**TOWN OF BAY HARBOR ISLANDS
DEVELOPMENT & REVIEW COMMITTEE MEETING
THURSDAY, NOVEMBER 9, 2023
11:00 A.M.**

**TOWN OF BAY HARBOR ISLANDS
COMMUNITY DEVELOPMENT
MEMORANDUM**

Subject: Site Development Plan Application (2023 New Design) – 3rd Review
Casa Verde Condominiums – Multifamily Residential Complex (43 DU)
1130 – 1140 - 1150 93rd Street
Bay Harbor Islands Acct. No. SPR23-000019
MMPA Acct. No. 01-0702-1165

LEVEL 1 FLOOR PLAN

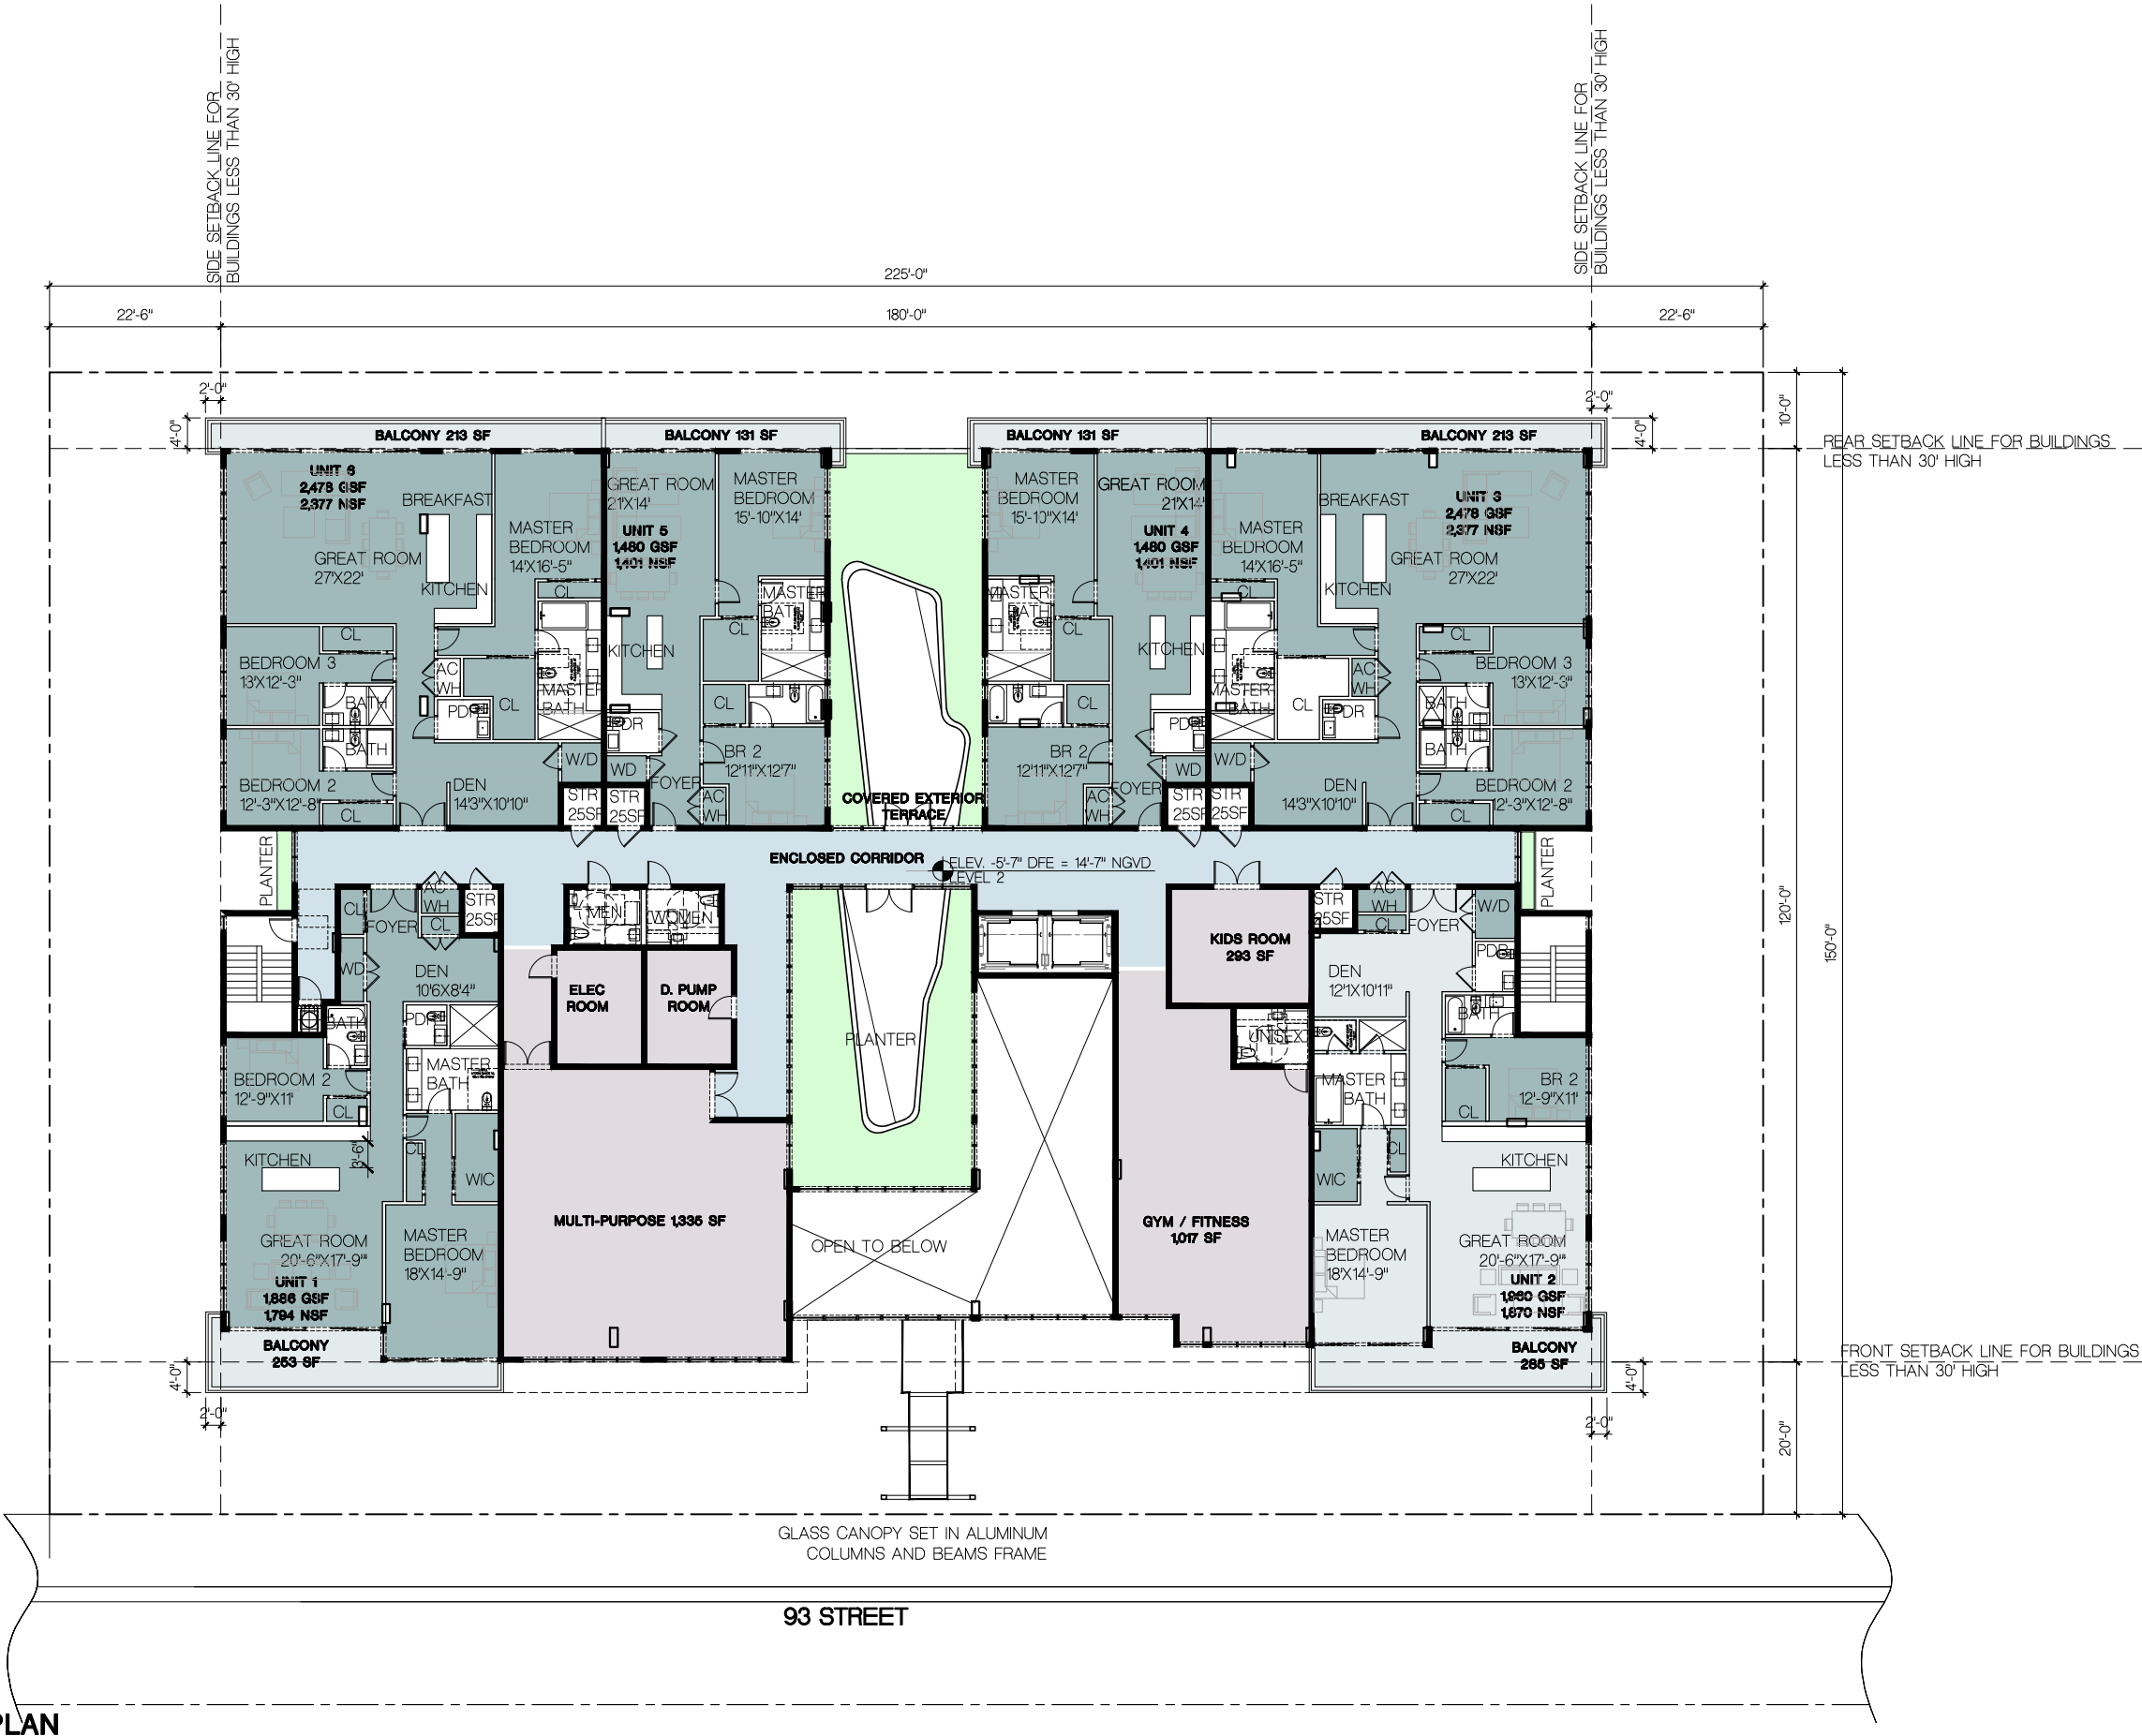
- 4) As previously requested, Site Plan Sheet A-1.01 shows a landscape strip along 93rd Street of 10’ as required near the western driveway. However, no dimensions are shown for the other front yard parking areas. Scaling the landscape strips still finds a min. 10’ width (landscaping only – not curbs) does not exist (9’+/-). Please dimension all the landscape strip widths and revise as necessary. If a waiver is being requested to provide less than 10’ of landscaping a written request is required with justification. The Code anticipated that some situations would arise due to the setbacks / guest parking / lobby drop-off criteria.

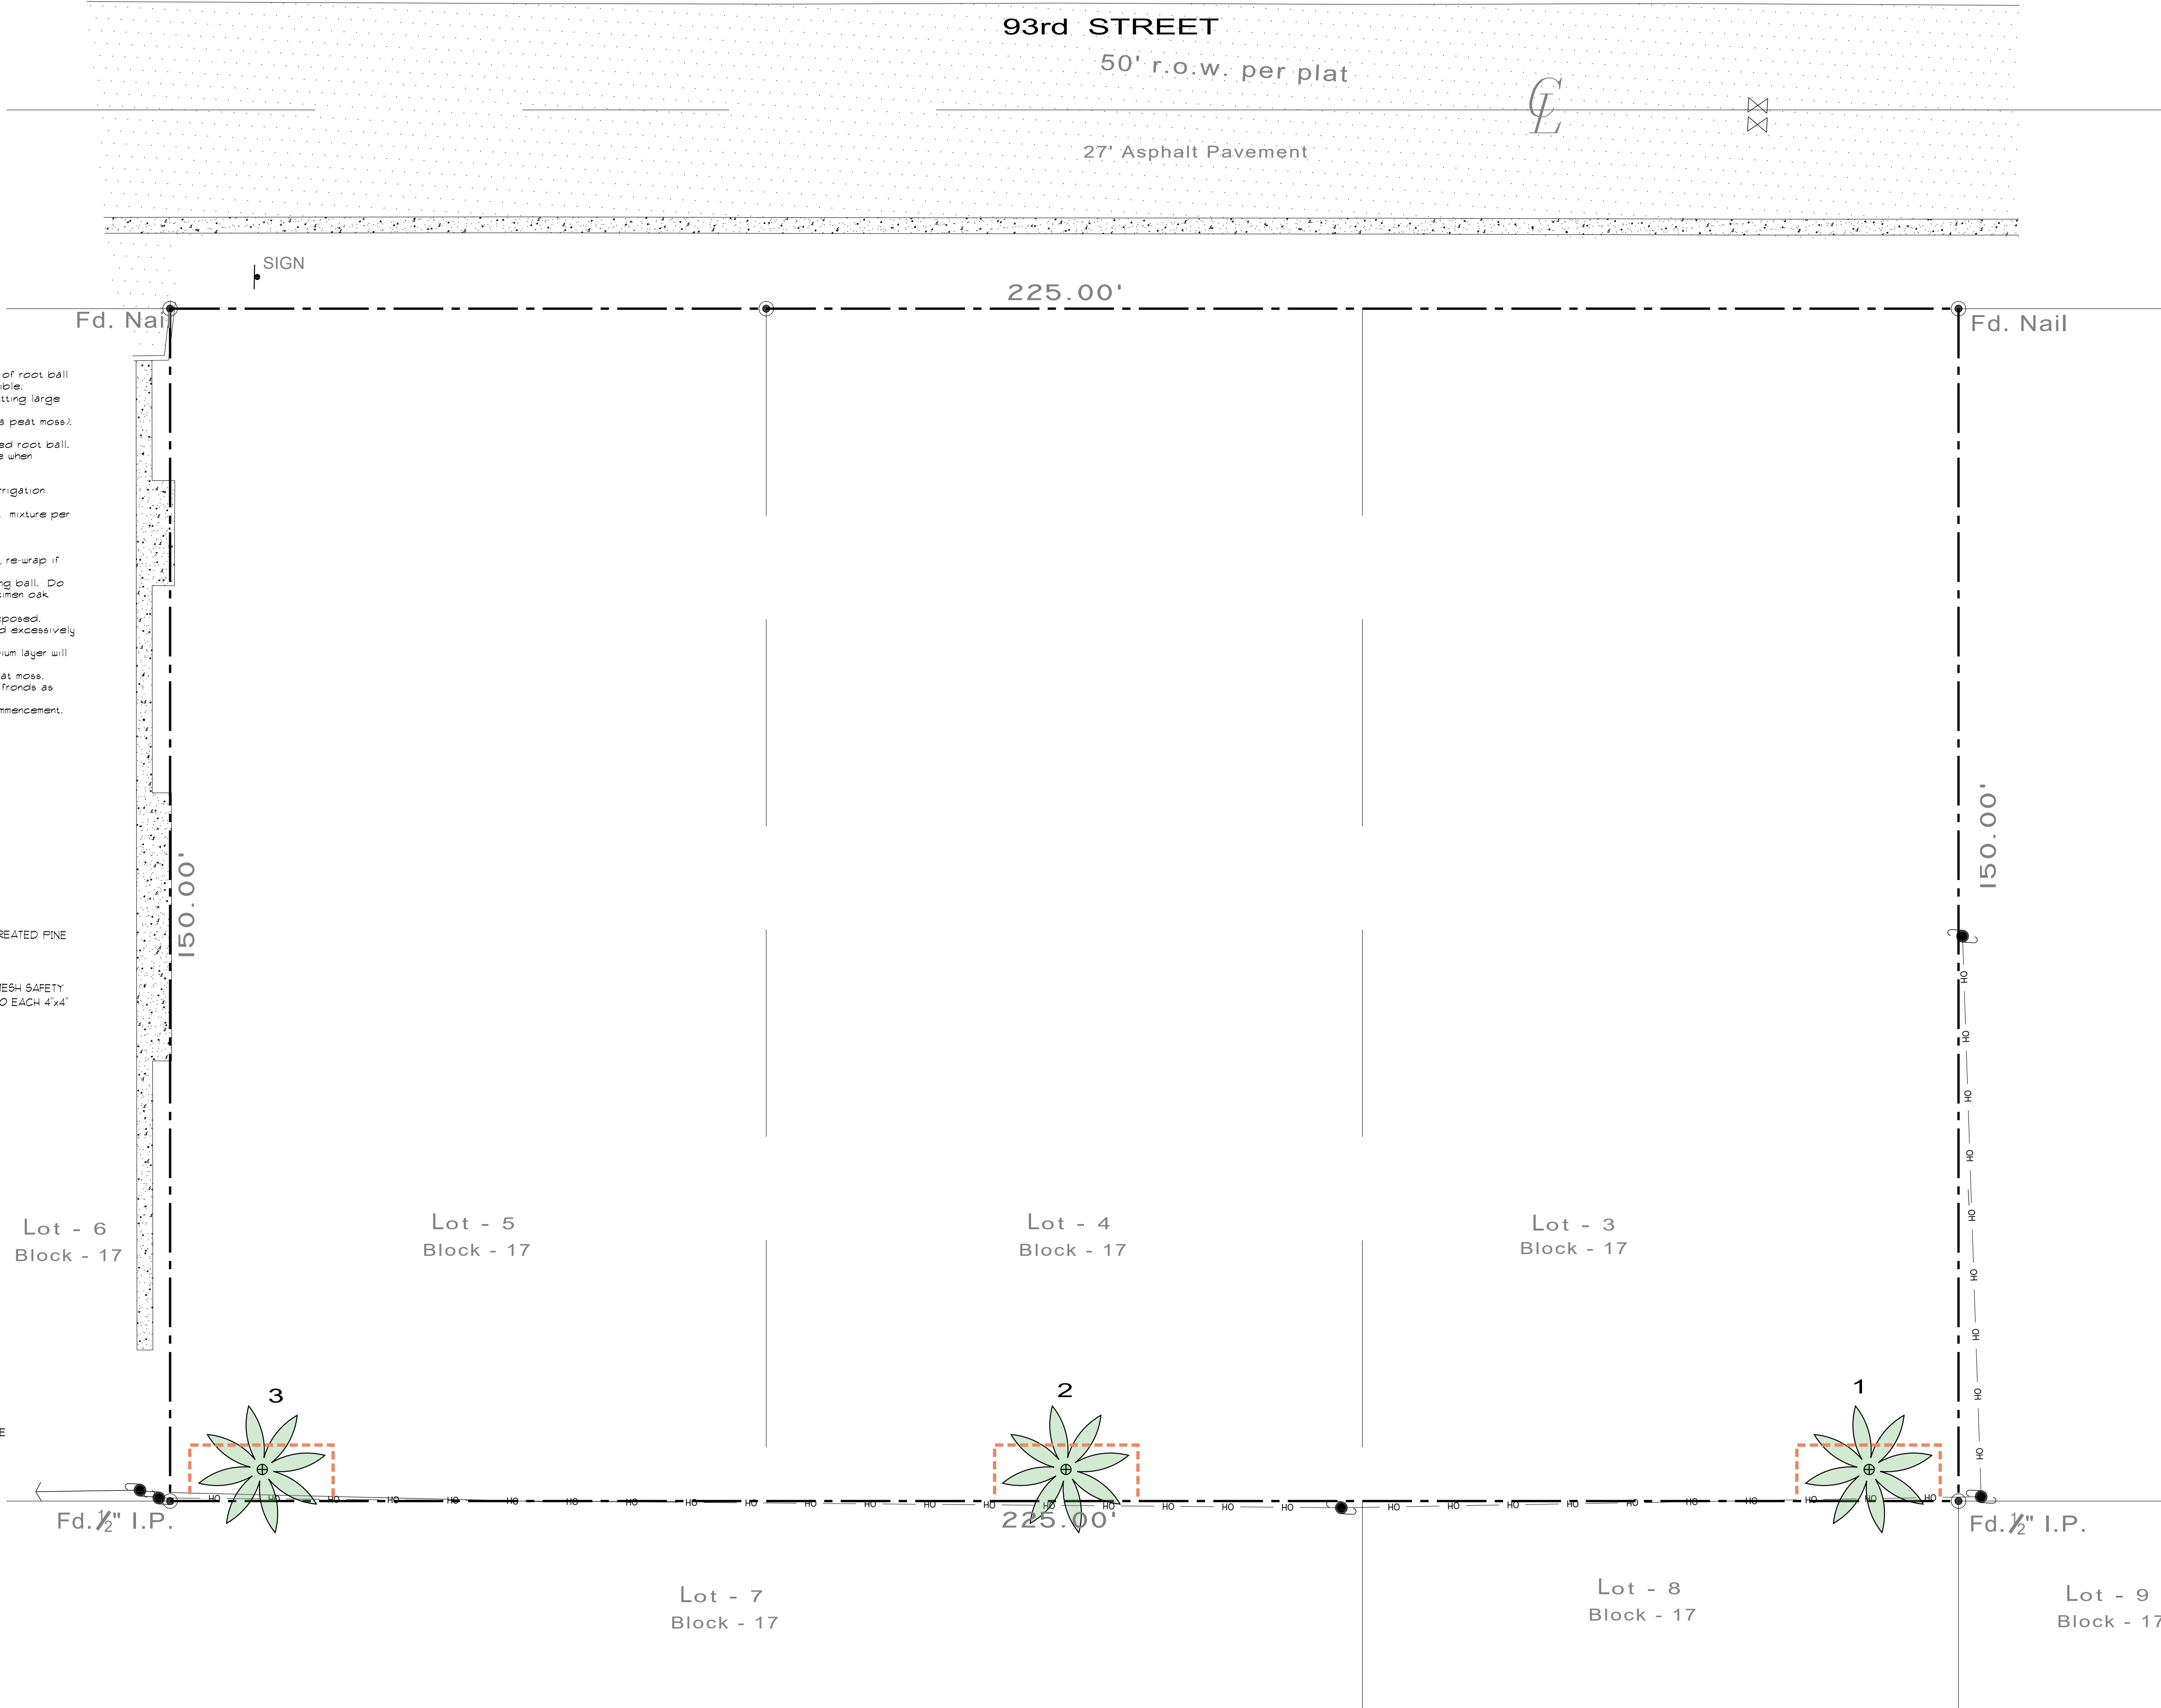
- 8) The Landscape Plans show an intent to install Pidgeon Plum shade trees along the south (rear) property line. However, these trees can grow quite large. There are existing power poles and overhead lines for FPL / telephone / cable / etc. along that property line. Per the FPL right tree / right place guidelines and Town Code these trees are not allowed as they would interfere with the lines. Select another shade tree species from the FPL list and revise the plans.
